APPLICATION FOR PLANNING PERMIT
(s.57(3) Land Use Planning and Approvals Act 1993)

Application No	SA 2020/004
Location	Cantara Road, Smithton
Applicant/Owner	516BHP Pty Ltd /Vukasinovic J R
Use Class	Subdivision
Proposal	Subdivision (1 Lot into 19 Lots)
Discretionary Matter	8.6.1 (P4) Lot design, 8.6.2 (P1) Roads, 10.6.1 (P1) Lot design, 10.6.2 (P1) Roads, C9.6.1 (P1) Lot design, C15.7.1 (P1) Subdivision within a landslip hazard area

REQUEST FOR ADDITIONAL INFORMATION – SA 2020 / 00004 - SUBDIVISION (1 LOT INTO 20 LOTS) - CANTARA ROAD, SMITHTON - TASMANIAN PLANNING SCHEME - CIRCULAR HEAD & LOCAL GOVERNMENT (BUILDING AND MISCELLANEOUS PROVISIONS) ACT 1993

Figure 9 Recommended Road Hump

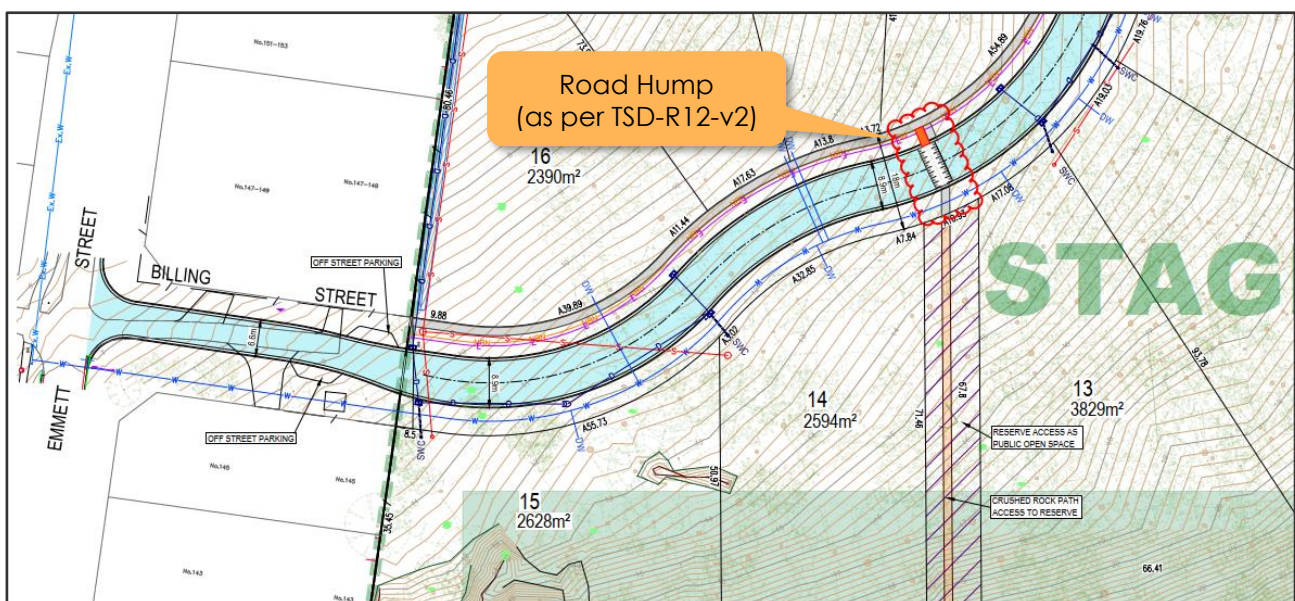
It is recommended that provision of a road hump, as shown in Figure 9 below, also be considered, given this would further assist with reducing vehicle speeds along Billing Street and could also be used to facilitate a pedestrian crossing that connects with the proposed footpath leading to the reserve to the south.

Appendix B- Plan of Subdivision

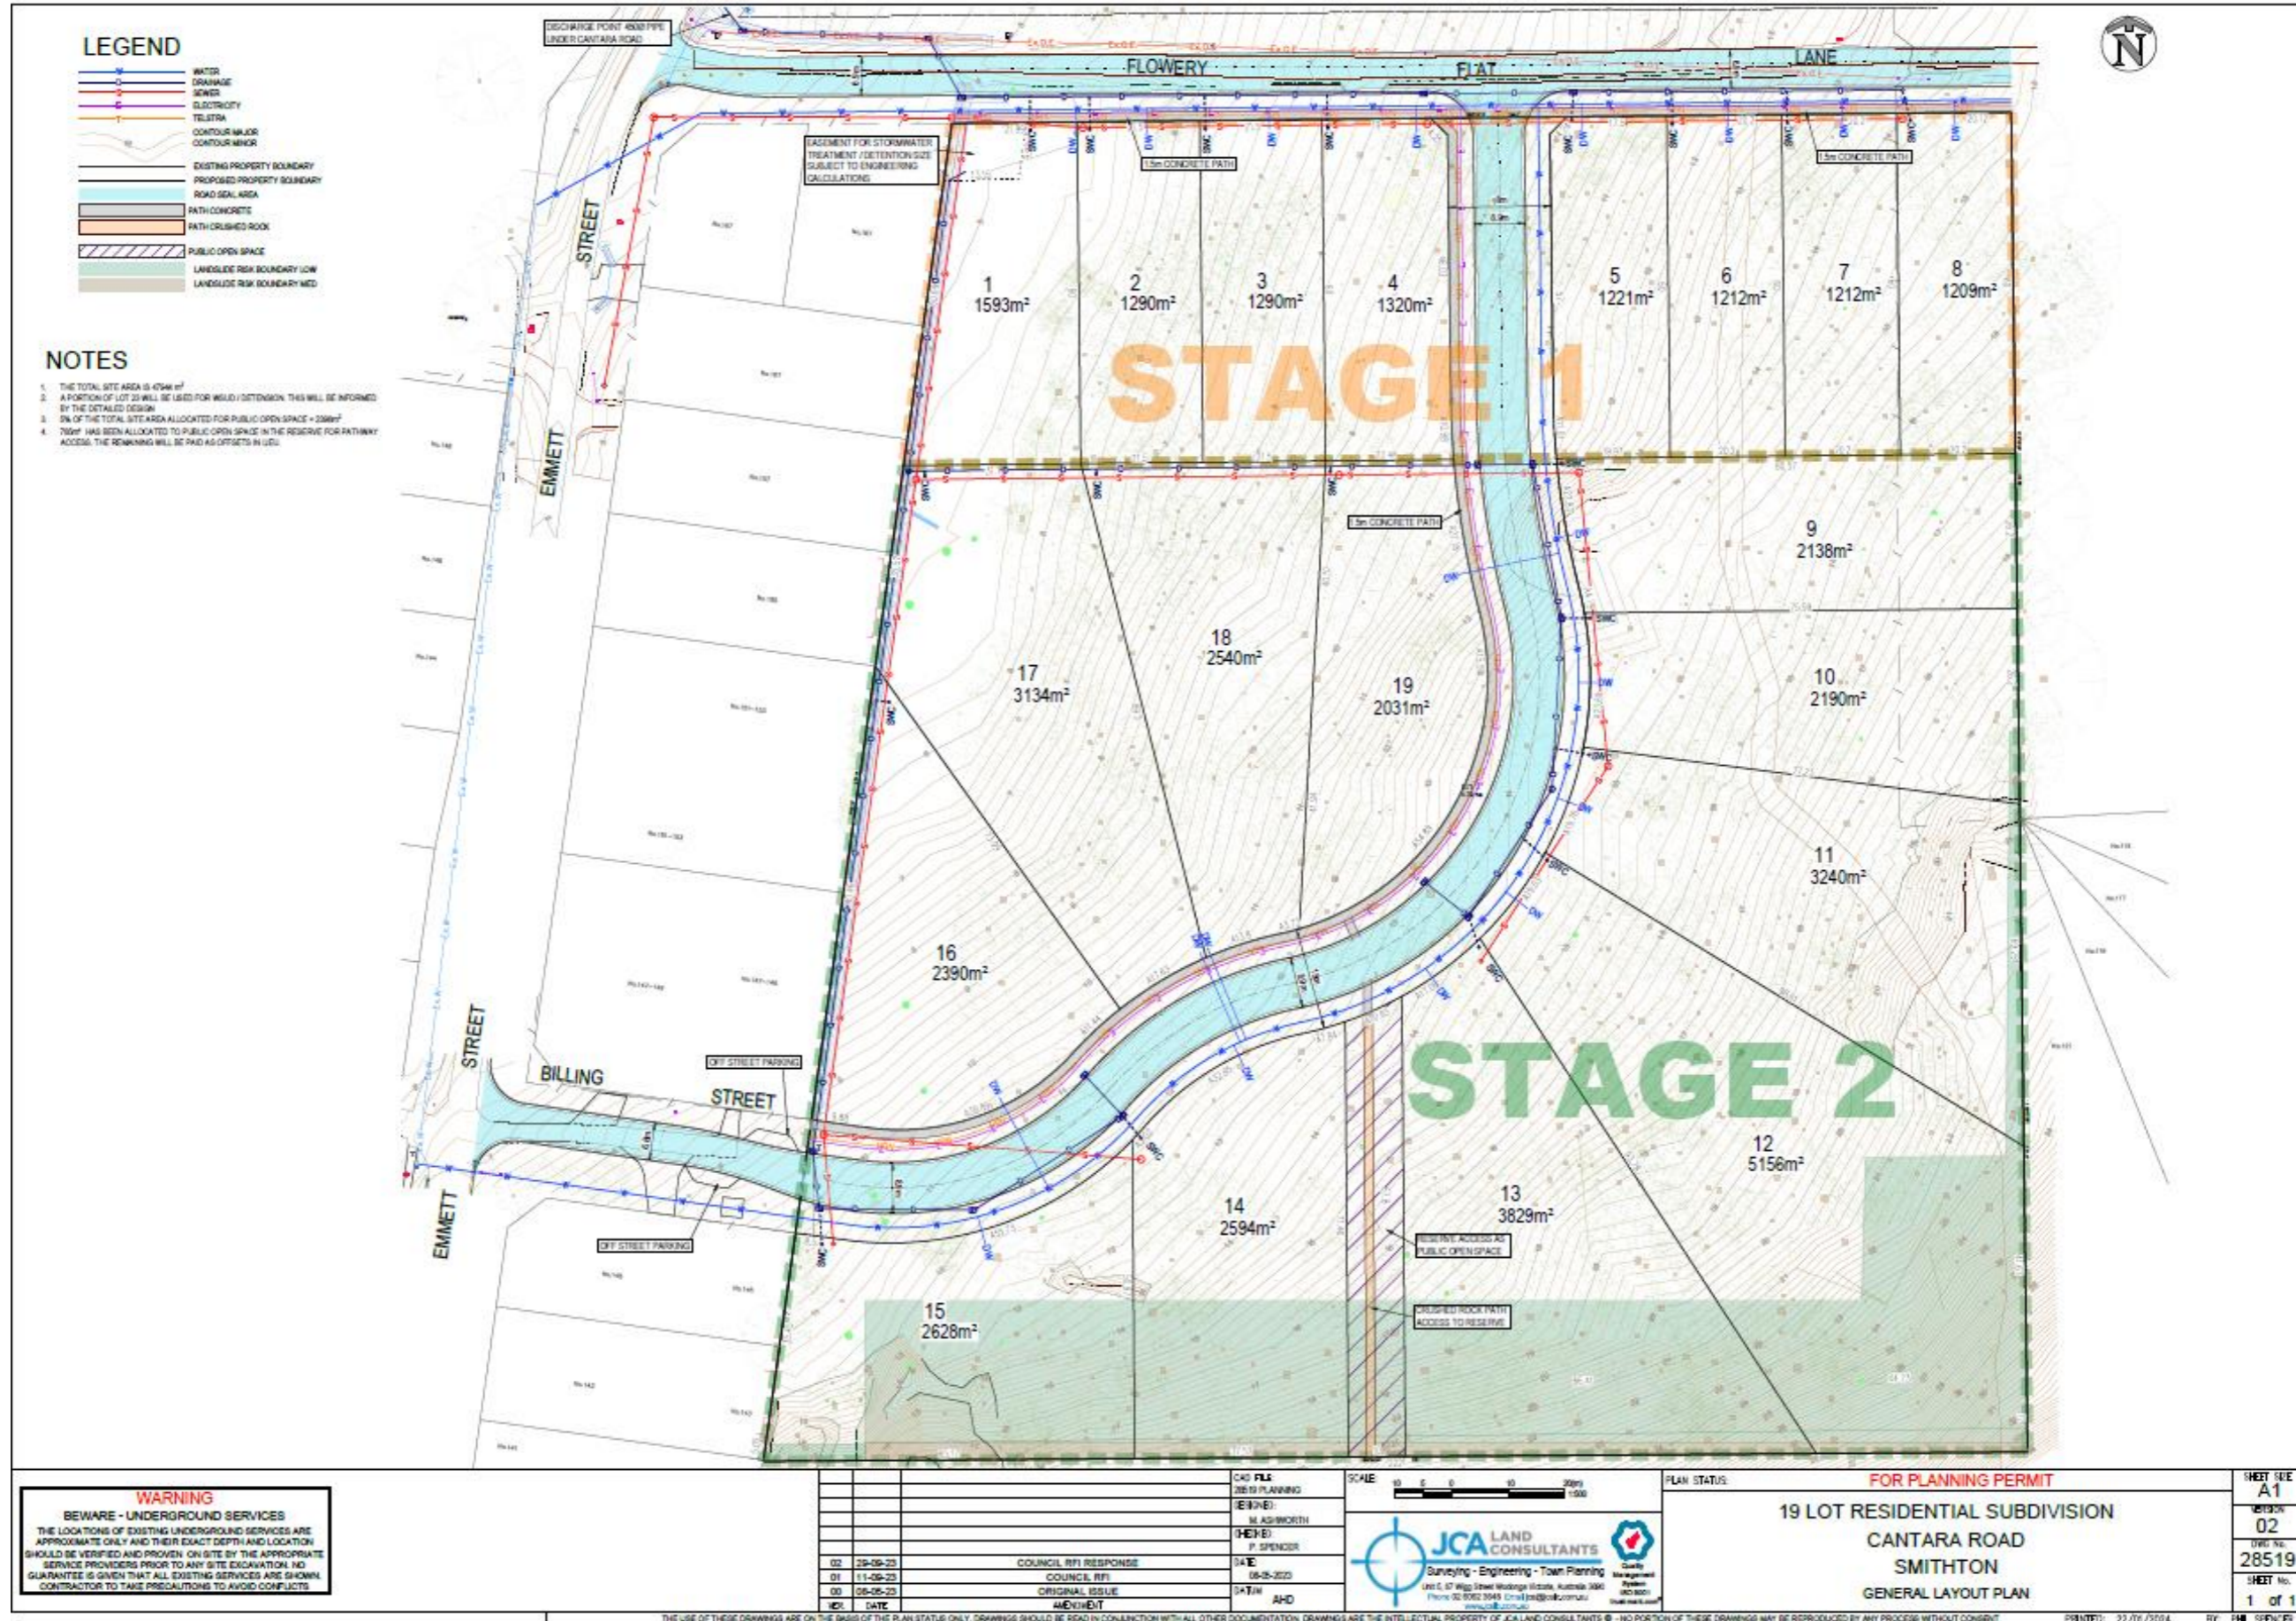
- Item 8. Regarding the submitted RFI Response Cover Letter, please provide a revised subdivision plan showing the amendment.
- Item 9. Given the differences in the number of new lots produced (19 vs 20 lots), lot size, lot frontage, building areas, and internal road design, the Council expects to have a statement from TFS or an accredited person to certify that the original BFHMP is still valid to determine the compliance of C13.6.1, C13.6.2 and C13.6.3 of the Bushfire-prone Area Code or a new BFHMP is required to demonstrate the compliance with the Code.
- Item 10. Majorly satisfied. Please revise the proposed subdivision plan to match Figure 2, Project No: TG23254/1-01 report, as prepared by Tasman Geotechnics and dated 7/12/2023.

A revised plan of subdivision is attached, which now matches the submitted figure 2, Project No: TG23254/1-01 Geotechnical report as prepared by Tasman Geotechnics and dated 7/12/2023.

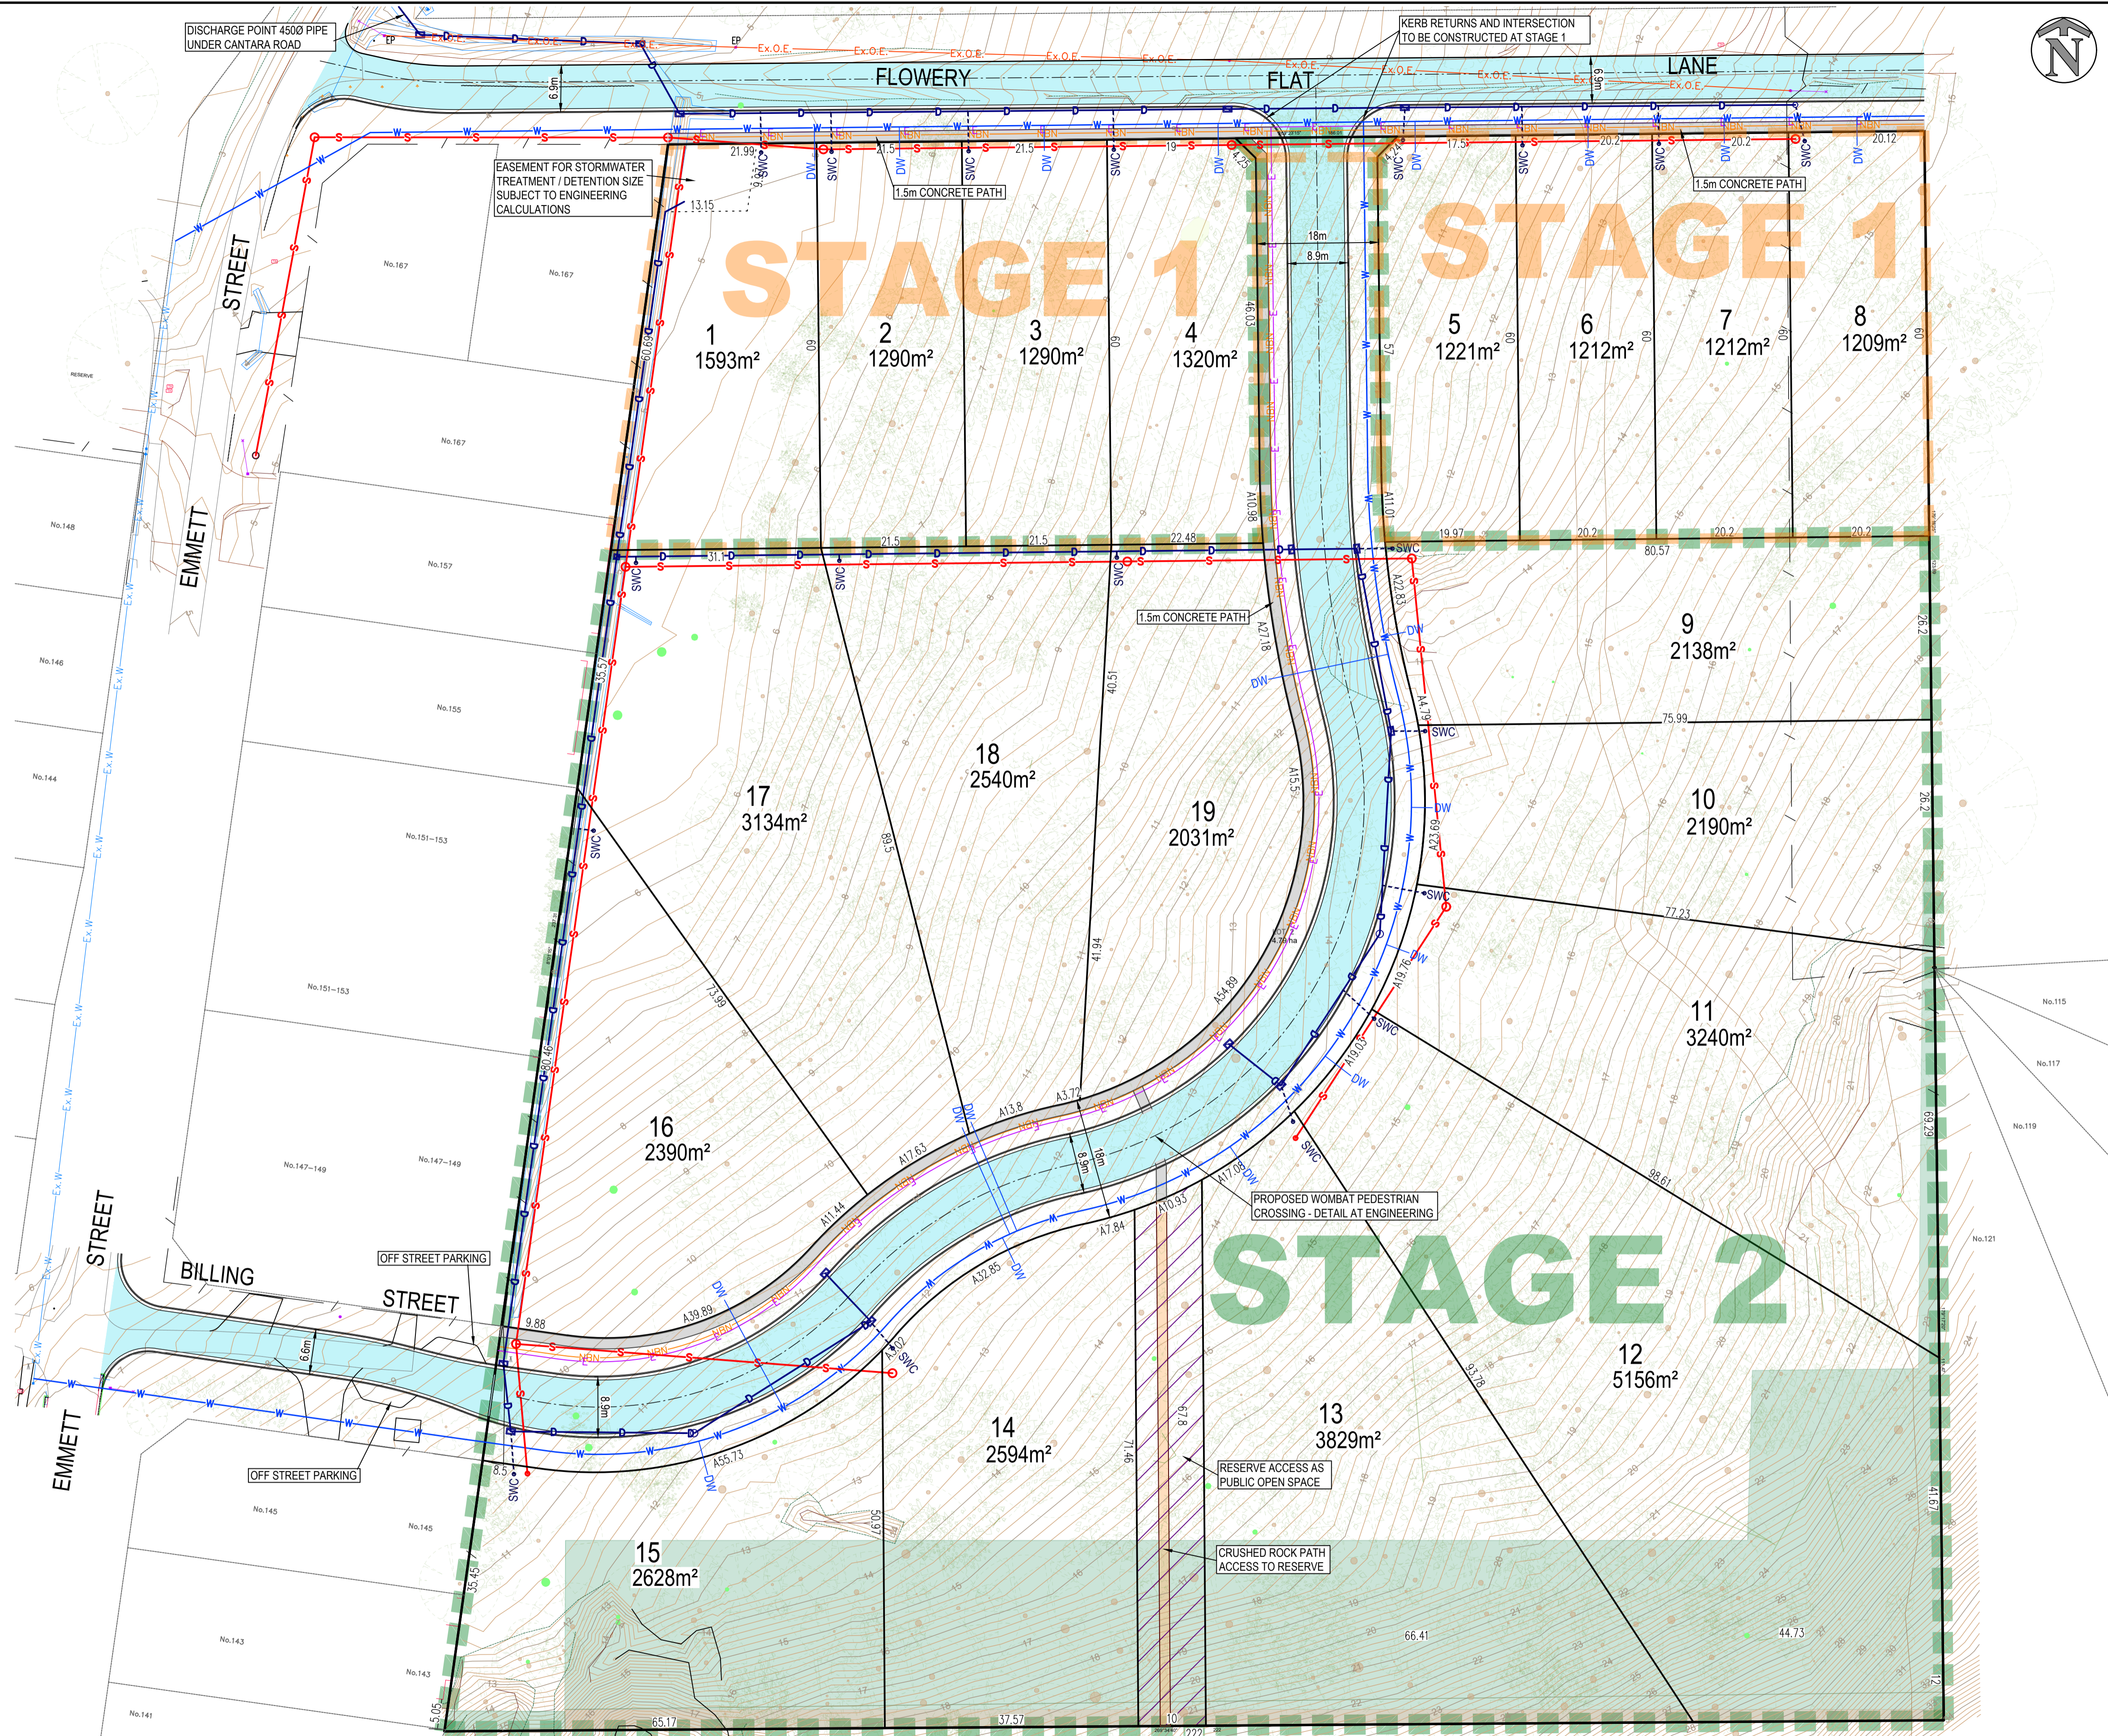
- a. As it appears that the revised proposal is for a staged subdivision, please provide the following information:
 - i. Please confirm if only the access road bell-mouth will be constructed during Flowery Flat Lane upgrade works required prior to sealing of the final plan for Stage 1, as shown in Stage 1 on General Layout Plan Drawing No 28519.

b Pedestrian Crossing located within the subdivision is intended to be used as a wombat pedestrian crossing, now shown on attached plan.
